STAFF REPORT
COMMUNITY DEVELOPMENT DEPARTMENT

HEARING DATE: 7/26/2022
 TO: Mayor & City Council
 FROM: Joe Dodson, Associate Planner
 208-884-5533
 SUBJECT: H-2022-0025
 Pickleball Court Subdivision
 LOCATION: Located at 4050 W. McMillan Road, at the northeast corner of N. Joy Street and W. McMillan Road, in the SE 1/4 of the SW 1/4 of Section 27, Township 4N, Range 1W.

Request for Annexation of 4.96 acres of land to be zoned from RUT in the County to the R-4 zoning district and a Preliminary Plat consisting of 14 single-family residential building lots and 4 common lots on 4.58 acres of land in the requested R-4 district, by The Land Group.

Preliminary Plat-Overview

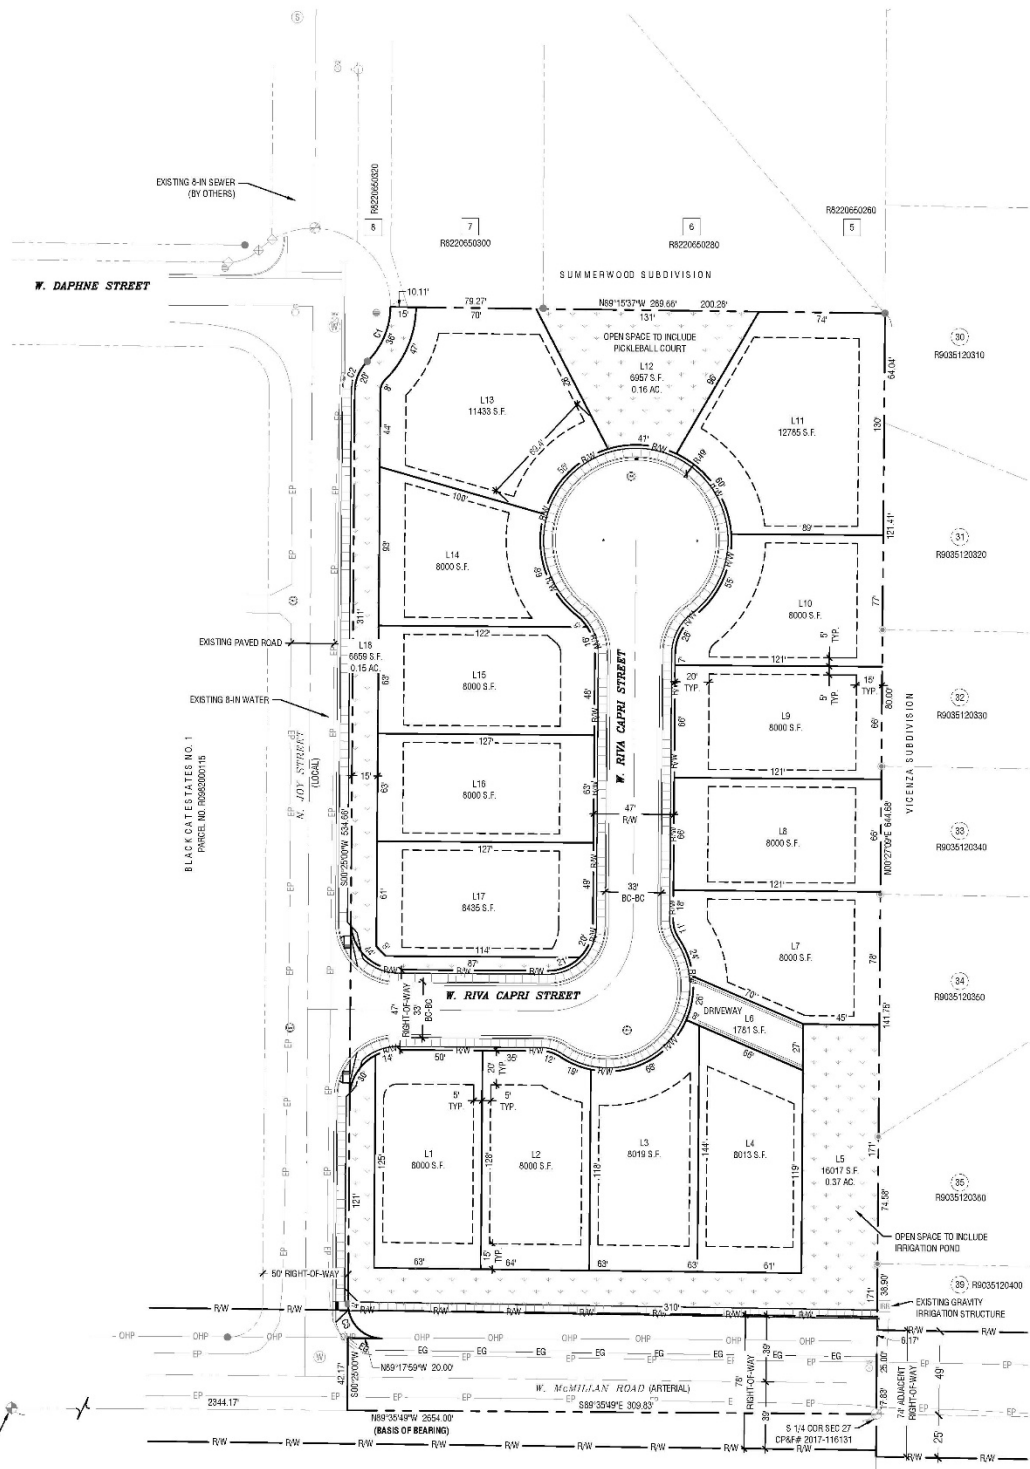
2. The preliminary plat included in Section VII.B, dated March 18, 2022, shall be revised as follows prior to submitting for Final Plat approval:
 - a. Ensure all lots meet the minimum lot size requirement for the requested R-4 zoning district of 8,000 square feet.

- b. Any existing accesses to W. McMillan Road shall be closed upon development of the site.
 - c. Correct the plat to show Lot 7 to take access from the common drive, Lot 6 OR revise the plat to show Lot 4 with the minimum required street frontage of 30 feet when along a curve and remove the common drive altogether.

- d. Depict the required 5-foot wide detached sidewalk within the landscape buffer along W. McMillan Road and place it at least four (4) feet north of the ultimate right-of-way line to allow for landscaping on both sides of the sidewalk and ensure it is detached from the roadway and allow the 25-foot buffer to be measured from the ultimate right-of-way instead of the back of the sidewalk, per UDC 11-3B-7C.1a OR place said sidewalk within ACHD right-of-way per the ACHD condition of approval.
